# TANDBERG PRODUCT BULLETIN

PREPARED BY: Prod. Lab/. T.B. B.S. DATE OF ISSUE: 11.1.78..... No.: TB 71E...

TAPE PATH PROBLEMS ON MOD. TCD 330 and TCD 310MK11.

PREPARED BY: Prod. lab. TB. .... DATE OF ISSUE: Feb. 1. -78 No. TB 72E

Fig.

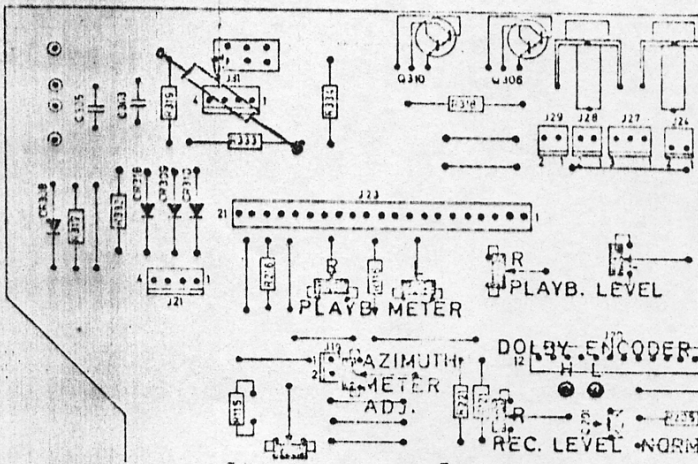
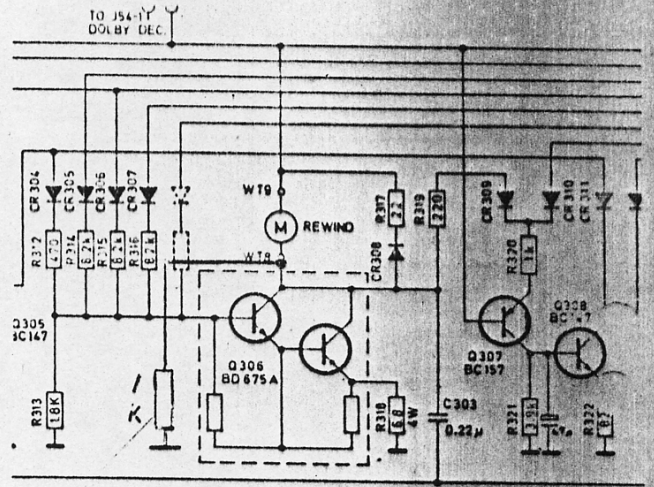
Modification: Introduction of back-tention on supply motor:  
 Resistor 1 kOhms, 1/2 W is connected as shown in fig.

All modifications including those described in P.B. No. 71 are carried out from Ser. no. 4181142. All machines in stock are also modified from shipping date Feb. 1. -78. The modified machines are marked with T on the identification label on carboard box.

*1 kohm 1/2 w*
